ADDENDUM No. 1
TO THE
CONTRACT DOCUMENTS FOR CONSTRUCTION OF
SUNSHINE PARK TRAILS EXPANSION
PROJECT # 20GR21

ISSUED THIS 16TH DAY OF JANUARY, 2026.

**SUNSHINE PARK TRAILS
EXPANSION**

TYPICAL TRAIL SECTION
SCALE: NTS

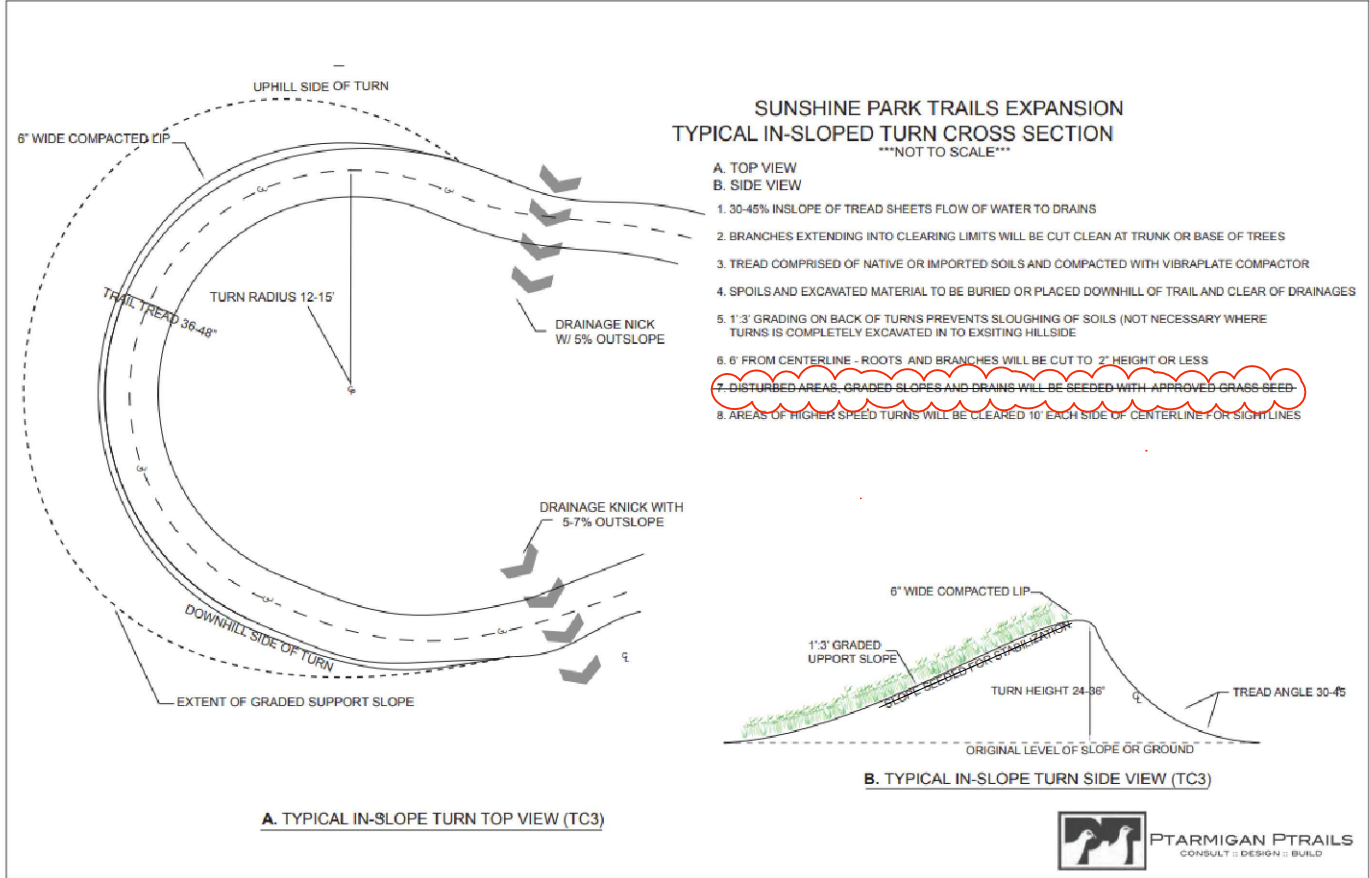
- **Removed** Seeding from Detail 1
- **Removed** Aggregate from Detail 2
- **Replaced** Table. See changes below:
 - Removed trail 7 from Universal Access.
 - Added trail 7 to beginner (class 2).
 - Changed Trail surfacing for Beginner (Class 2) and Blue Flow (Class 3) to be compacted native unless Schedule B – Alternate Bid is selected.
